UNITED STATES PATENT AND TRADEMARK OFFICE

10/565,156

Office Action Summary	Application No.	Applicant(s)	
	10/565,156	MACHIDA ET AL.	
	Examiner	Art Unit	
	Paresh Patel	2829

DETAILED ACTION

FIG. 35

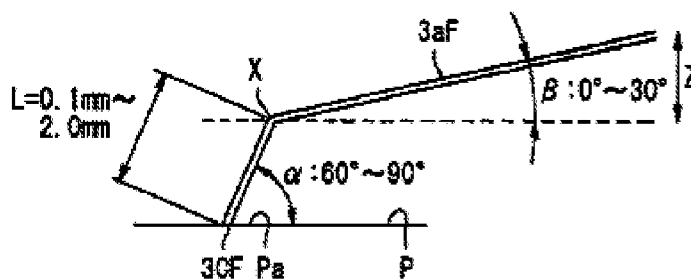
Regarding claim 1, as best understood by the Examiner, Yoshida et al. (hereafter Yoshida) in **fig. 35-37** discloses a probe (**see fig. 37 or 1F**) comprising:

a base part [**3F and 3aF**] being formed of a first material having a first thermal expansion coefficient and including a tip end [**3aF**], the tip end being, adapted to contact an electrode of an object to be measured almost perpendicularly and scrub the electrode [**see fig. 35**], and

and in that said contact part is deformed in a direction **almost** perpendicular to the longitudinal direction of said base part due to respective thermal expansion of said base part and said junction part **[portion of L bends almost perpendicular when it contacts the P with $\alpha = 90^\circ$]**.

FIG. 37

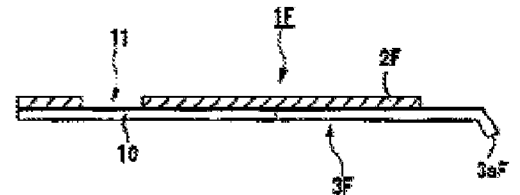
an almost rectilinear contact part [**wiring pattern 3F and element 2F of probe 1F**]; and

a base end [**portion 10 of 1F**] continued to the contact part,

an almost rectilinear junction part [**2F**] which is formed of a second material [**resin film 2F**] having a second thermal expansion coefficient different [**different**

because of resin of 2F and conductor of 3F] from that of the first material and provided integrally and longitudinally along a widthwise end **[see fig. 37]** of the base part exclusive of the tip end,
